**TENDER FOR SUPPLY OF 66KV BUSHINGS & MACHINE SPARES FOR TANA POWER STATION.**

**TENDER No. KGN-HYD(Tana)-05-2021**

## CLARIFICATION NO. 1

PICTURE;

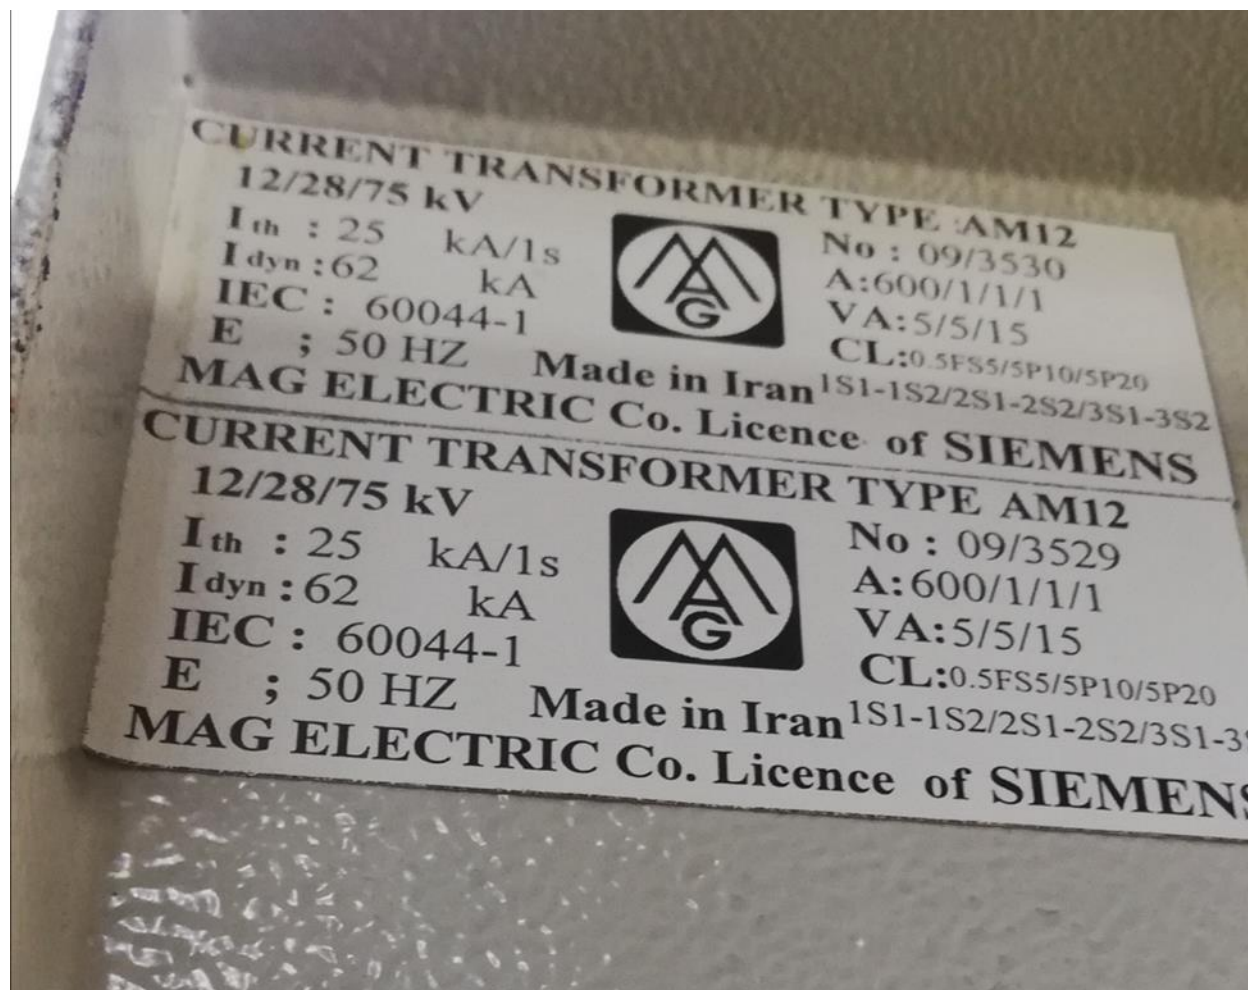
No.	Bidder's Question	KenGen's Response
1	Please clarify on the rated voltage data of Current transformer 600A, 400A, 2500A, 50A. Every manufacturer i contacted asked for the rated Voltages, assist on that	The current transformers are intended for use in a 11kV circuit. Let them refer to 'MAG ELECTRIC Co. TYPE AM12' for guidance.
2	Please provide name plate pictures of Cts so that we can get the best quality.	As per below picture provided.
